SIAMESE PONDS WILDERNESS AND JESSUP RIVER WILD FOREST

Amendments

2005 Siamese Ponds Wilderness Unit Management Plan

2006 Jessup River Wild Forest Unit Management Plan

Figure 9. Approximate location of Clear Pond Trail re-route

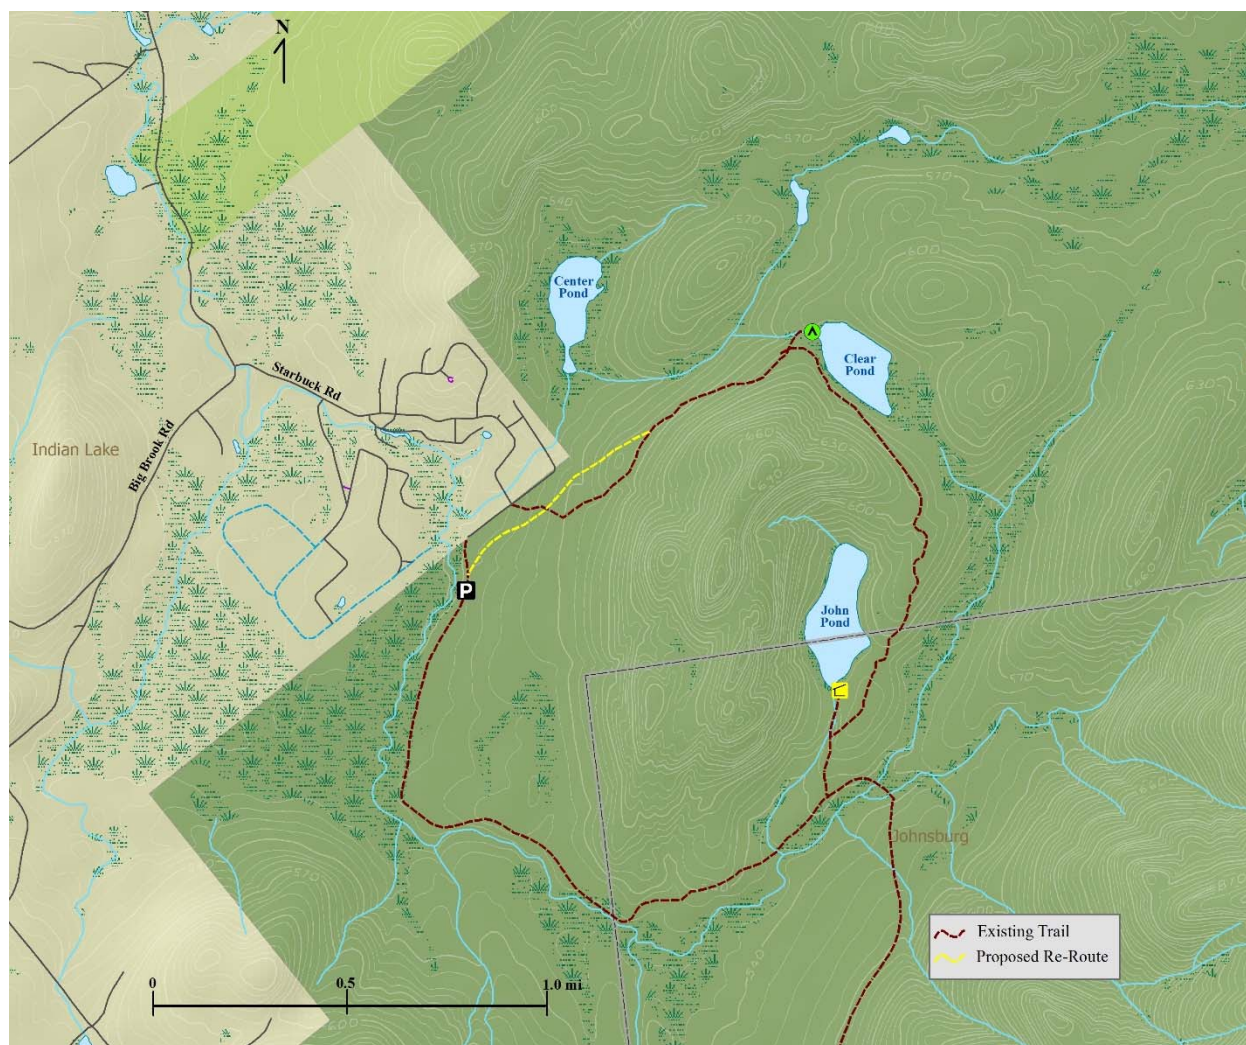
In Siamese Ponds Wilderness, the Clear Pond Trail, now part of the Clear Pond-John Pond Loop, requires a short re-route to move the trail off the fall line, reduce the grade and make the full loop more optimal for skiing. The re-route would be up to 0.75 miles in length.

Comment: We do not see a need for the small re-route of Clear Pond Trail.

Response: *The small re-route will allow for the recreating public to complete a loop without having to use a public road, and will avoid the current rocky access point across the drainage ditch while also creating a gently sloping trail off of the fall line.*
